Additional Response to Submission

City of Sydney (R/2016/41/B)

/ View of Guardian Square from Pyrmont Bridge

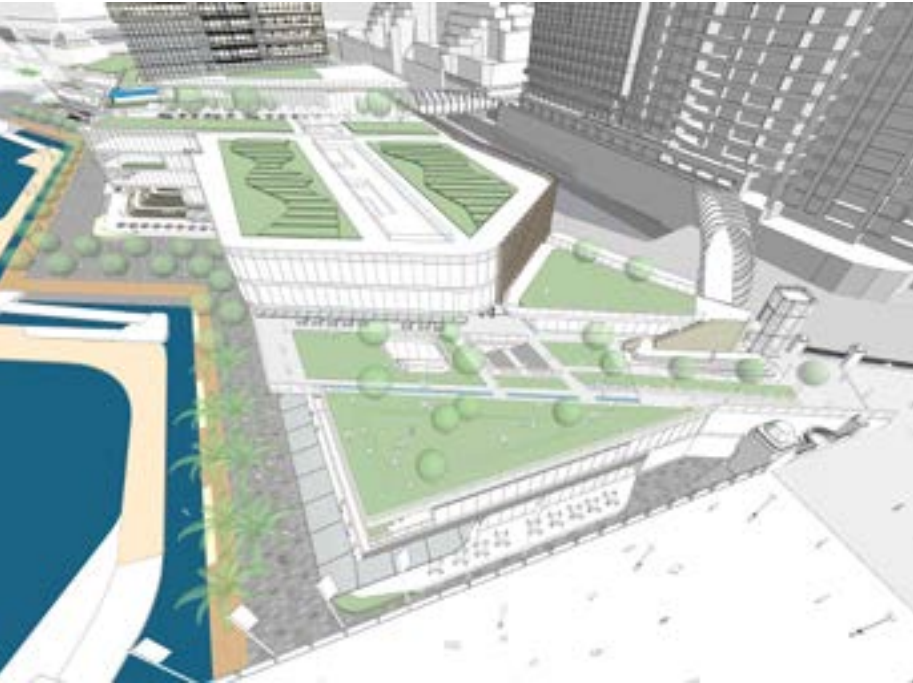
Comments	Response
3. Heritage	
It is acknowledged that the amended building envelope responds to the City's recommendation for a lowered podium height to the north of the development. It is also noted that the lowered podium follows a 30-degree angle sightline and separation from the Pyrmont Bridge.	The proposed built form has been developed following the completion of a number of workshops between the Department of Planning and Mirvac. The outcome of which included proposed further refinements to the built form of the podium and tower, with the refinements considered to be positive.
However, the amended envelope demonstrates a tiered podium to the north with varying levels of RL 25 and RL13.25. The RL 13.25 lower tier is still considered excessive and blocks sightlines from the Bridge. To enable clear site lines and uninterrupted views from the west, the lower tier is recommended to be further reduced to be no higher than the Bridge surface, at approximately RL 11.5.	One of the key refinements following the workshops with the Department is the reduction of height and bulk of the northern part of the podium. It has been reduced by 1 to 3 storeys, from RL 25m to part RL 17.6m and part RL 13.75m. The rooftop of this section of the podium will instead comprise a new public space; 'Guardian Square'.

Further, the improve the relationship of the development with surrounding buildings, the north-east corner of the podium should replicate the slanted building alignment of the Maritime Museum so as to increase the openness of the underbridge public open space.	The height of the envelope adjacent to the Pyrmont Bridge at RL13.75 seeks to allow for balustrades and varying soil depths to support a diversity of planting while maintaining clear sight lines from the west and the adjacent Pyrmont Bridge.
	Refer to 'Architectural Design Report (Appendix D)' prepared by fjmt and 'Response to Submissions and Further Amended Concept Proposal' prepared by Ethos Urban for more information.
